UNITED STATES PATENT AND TRADEMARK OFFICE

APPLICATION NO.	FILING DATE	FIRST NAMED INVENTOR	ATTORNEY DOCKET NO.	CONFIRMATION NO.
10/037,304	12/31/2001	Huanong Zhang	X02.12-0001	4512

Office Action Summary

DETAILED ACTION

FIG. 5

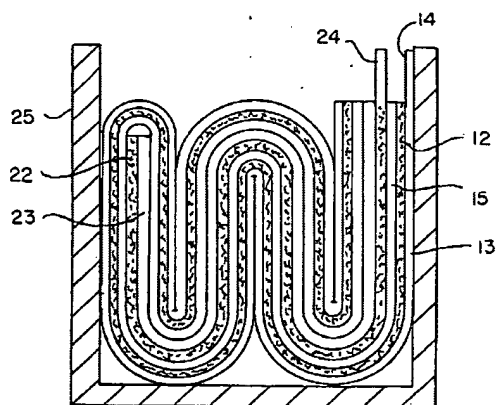
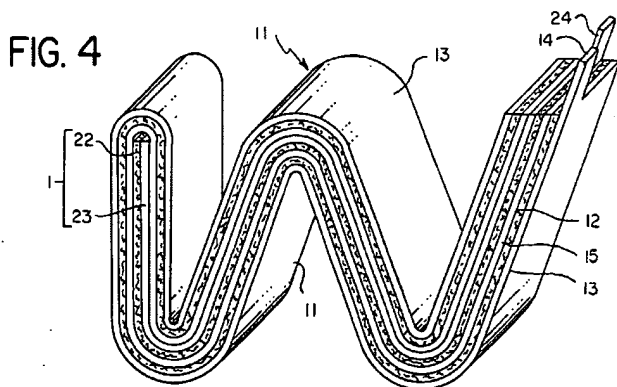
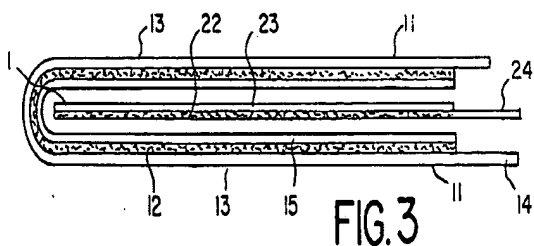
Figures 3, 4 and 5 below show the electrode assembly wherein the method for assembling the same including folding the entire anode over the entire cathode to form an alternately laminate structure in which the cathode 1 is sandwiched between the folds of the anode 11 (COL 3, lines 1-6). It is further disclosed that the invention works equally well when the separator is placed over the cathode (COL 2, lines 45-48).

Figures 3, 4 and 5 above illustrate one plate being folded into a continuous S-shape along with the separator integrally, and the other plate being sandwiched (*inserted*) in the laminated area (COL 3, lines 1-6).

Figures 3, 4 and 5 above also depict the plate having a continuous S-shape folded plate and the notches (*the V-shaped indentation or fold*) provided at the cross-positions of the two plates (COL 3, lines 7-19).

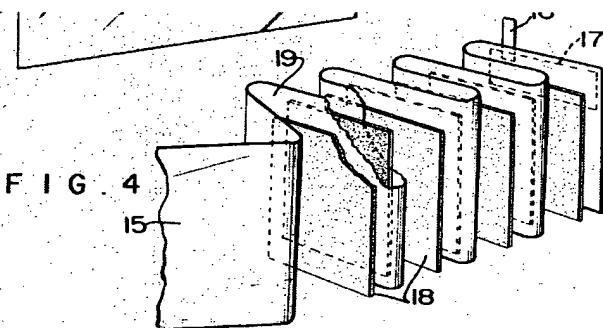
Figure 4 below illustrates the assembled battery group wherein the anode plate is folded; the positive and negative plate alternately arranged, the cathode plate being inserted into a laminated area of the anode plate and the separator.

The lithium anode 15 provided with its electrical connection means is slipped into the separator sheath through its open mouth S^2 . Then the assembled anode and sheath 55 are zig-zag-wise folded or pleated on a master gauge and cathode plates are placed between the adjacent pleats resulting from the zig-zag folding as illustrated in FIG. 4.

FIG. 4 diagrammatically shows a perspective view with broken-away portions of part of the unit of anode and 60 cathode plates; however, the sheath shaped separator S enclosing the anode 15 and the electrical connection means associated with the cathodes have not been shown in this figure for clarity's sake.

The anode 15 provided with its electrical connection 65 means 16, 17 is made by folding or pleating the plate 15 of FIG. 3 enveloped in sheath S upon itself. Between each pair of pleats is placed a cathode plate 18 having the shape of a thin substantially rectangular plate. A cell may thus be constituted by folding the anode eight times 70 in order to constitute seven folds and placing seven cathode plates in the pleats between these folds.
